Joint Pre-Submittal Meeting for

License Amendment Requests: Improved Relaxed Axial Offset Control (RAOC) F_Q Surveillance Technical Specifications

December 12, 2019

Proposed TVA
WBN Unit 1 TS
Markups
(similar
changes also
being made for
WBN Unit 2)

F_Q(Z) 3.2.1

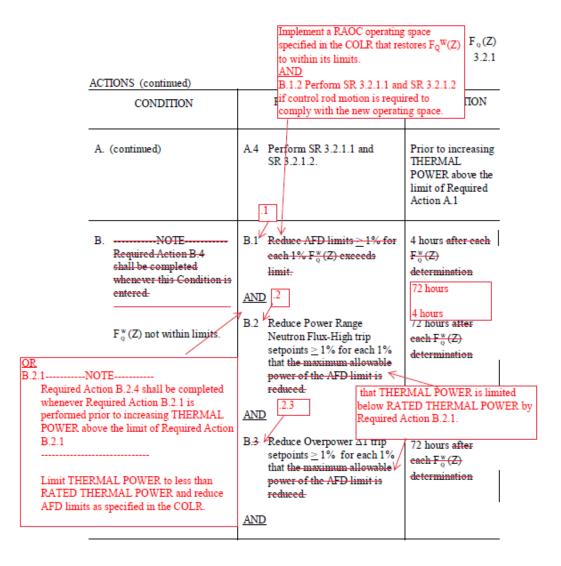
- Proposed TS Changes
 - TS 3.2.1 Condition A
 - TS 3.2.1 Condition B
 - SR 3.2.1.1 and SR 3.2.1.2
 - TS 5.6.5
- Schedule Milestones
 - Submit February 2020
 - Approval Requested by March 2021
 - Implement after each unit's next refueling outage following approval (unit specific Tech Specs until both units implement)

- 3.2 POWER DISTRIBUTION LIMITS
- 3.2.1 Heat Flux Hot Channel Factor (F o (Z))
- LCO 3.2.1 $F_{_Q}(Z)$, as approximated by $F_{_Q}^{\,c}(Z)$ and $F_{_Q}^{\,w}(Z)$, shall be within the limits specified in the COLR.

_	
CONDITION	REQUIRED ACTION	COMPLETION TIME
ANOTE Required Action A.4 shall be completed whenever this Condition is entered	A.1 Reduce THERMAL POWER ≥ 1% RTP for each 1% F c/Q(Z) exceeds limit.	15 minutes after each F c/Q(Z) determination
Prior to increasing THERMAL POWER above the limit of Required Action A.1. SR 3.2.1.2 is not required to be performed if this Condition is entered prior to	A.2 Reduce Power Range Neutron Flux - High trip setpoints ≥ 1% for each 1% F ^c _Q (Z) exceeds limit.	72 hours after each $F_q^c(Z)$ determination
THERMAL POWER exceeding 75% RTP after a refueling.	A.3 Reduce Overpower ∆T trip setpoints ≥ 1% for each 1% F ^c _Q (Z) exceeds limit.	72 hours after each F c (Z) determination
		MAL POWER is limited ED THERMAL POWER by
Prairie Island Units 1 and 2	Omt I -	Amendment No. 138 Amendment No. 149
